Re: Appeal of CEQA Categorical Exemption Determination
Planning Case No. 2013.1383ENV
Building Permit Application Nos. 2013.12.16.4318 & 2013.12.16.4322
3516-3526 Folsom Street ("Project Site")

**Categorical Exemption Appeal
3516-3526 Folsom Street**

DATE: December 5, 2016
TO: Angela Calvillo, Clerk of the Board of Supervisors
FROM: Lisa Gibson, Acting Environmental Review Officer – (415) 558-9032
Joy Navarrete, Senior Environmental Planner – (415) 575-9040
Justin Horner, Environmental Coordinator – (415) 575-9023
RE: Planning Case No. 2013.1383ENV
Appeal of Categorical Exemption for 3516-3512 Folsom Street
HEARING DATE: December 13, 2016
ATTACHMENTS: A. Categorical Exemption Determination

Discretionary Review Hearing
Case Numbers:
2013.1383DRP-10 & 2013.1768DRP-09
3516 & 3526 Folsom Street

Figure 4: PG&E transmission line relative to proposed site plan.

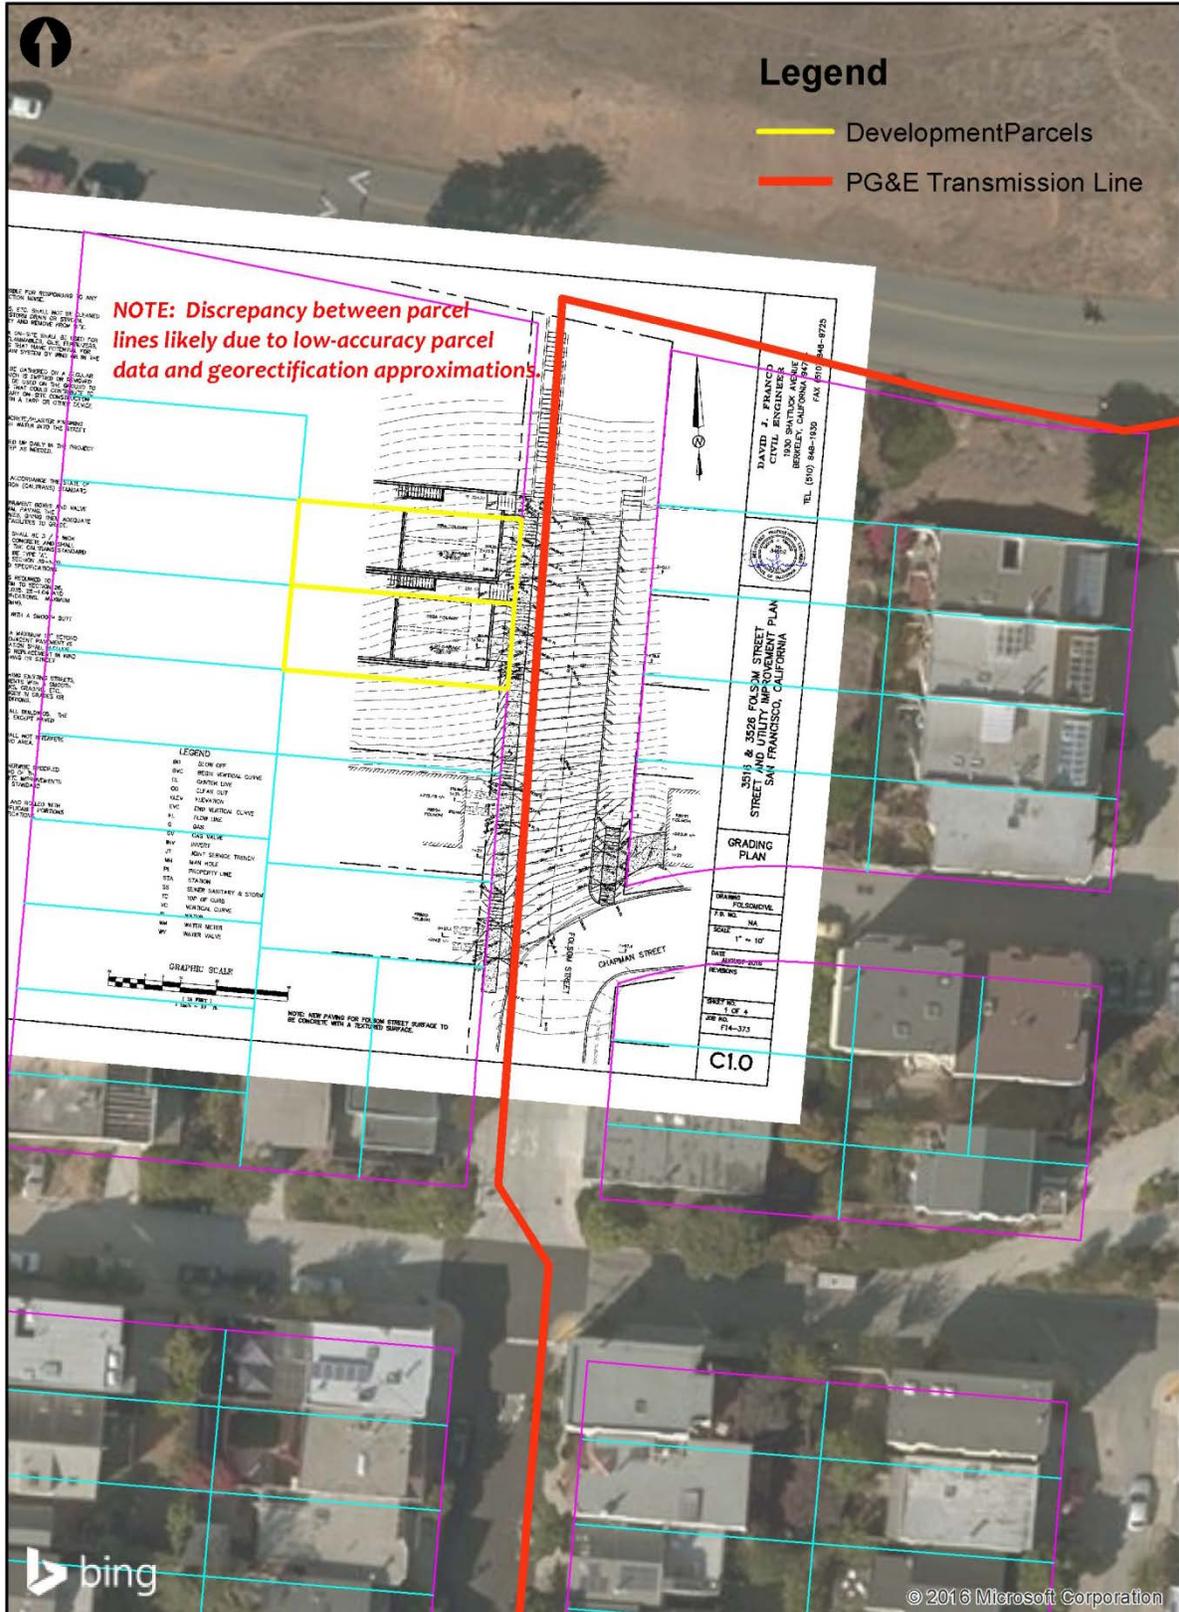
The proposed projects are located immediately adjacent to a major PG&E transmission natural gas pipeline (Figure 1, Figure 2, Figure 3). This major pipeline is located immediately below the primary access road for the construction (Figure 4, Figure 5), immediately adjacent to significant proposed new utility work (e.g. gas service, water supply, sewer) as well as removal of existing pipeline soil cover (Figure 6, Figure 7), and immediately adjacent to significant proposed bedrock excavation (depths on the order of 6 to 10 feet per the submitted architectural elevations (such as sheet A-3), as seen in .
